Delegated Report

Householder Planning Application

Application No: 20230753

Description: Create a driveway and a cross over.

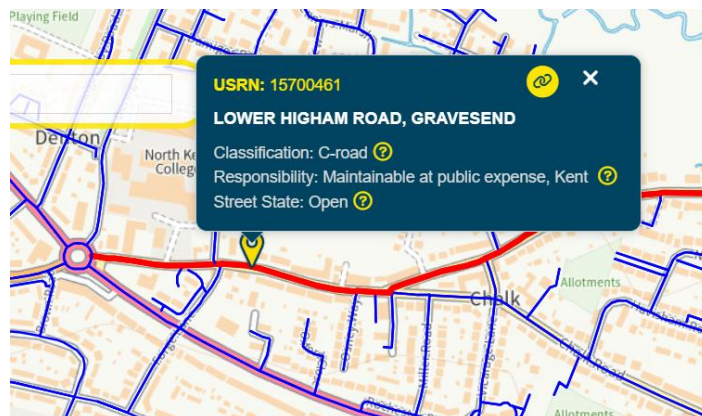
Manual for Streets, which is accepted as undergoing revision but not yet published, is the guide that should be used when considering sight line requirements at junctions, which includes accesses. On page 92 paragraph 7.7.6 states,

- 7.7.6 An X distance of 2.4 m should normally be used in most built-up situations, as this represents a reasonable maximum distance between the front of the car and the driver’s eye.

- 7.7.7 A minimum figure of 2 m may be considered in some very lightly-trafficked and slow-speed situations, but using this value will mean that the front of some vehicles will protrude slightly into the running carriageway of the major arm. The ability of drivers and cyclists to see this overhang from a reasonable distance, and to manoeuvre around it without undue difficulty, should be considered.

The ‘X’ distance is the distance measured from the edge of highway along the centre line of the driveway and gives an approximation of where a driver may be expected to be seated when exiting the drive, (assuming that the vehicle has been reversed onto the driveway)

Chalk Road and Lower Higham Road also form a rat run for drivers wishing to avoid the queues on the A226 at the nearby roundabout during the morning peak. Therefore, whilst at times it may appear that Lower Higham Road may be lightly trafficked this is not always the case and the use of 2m for an ‘X’ distance is considered inappropriate.

Table 7.1 Derived SSDs for streets (figures rounded).

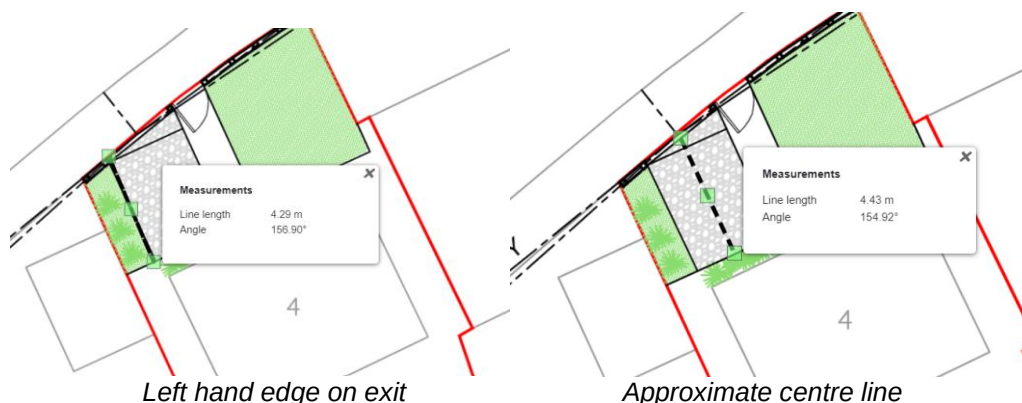
With regards to the ‘Y’ distance the distance measured along the nearside drive from the centre of the driveway. Manual for Streets suggests that 43 metres is appropriate for a 30mph road, although it may be possible to review this, if a speed survey over several days is available. As the 43 metre sight line crosses land outside the applicants control, it is impossible to control and is obstructed by a boundary fence and plants looking at the Google Street View Images of November 2022

With regards to the 30 metre option, this is only suitable for a speed of approximately 20mph, which requires 25 metres, the next speed in the table is 25mph and this requires a sight line of 33 metres. But is also fails because the 'X' distance is insufficient.

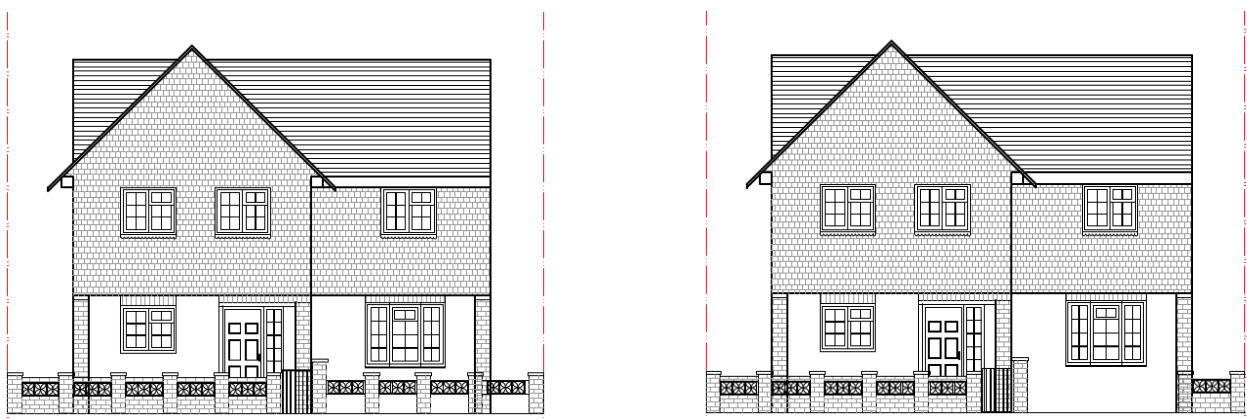
The proposed development will not significantly alter the appearance of the property's frontage. The existing pedestrian access will be retained and a section of the low-level boundary wall removed for the vehicular access (as shown in the comparison screenshots below):

With the exception of the driveway and straightening of the pedestrian access, the remaining front garden of the property will be retained as soft landscaping, which along with the retention of the front boundary wall will reduce the impact of the development on the street scene.
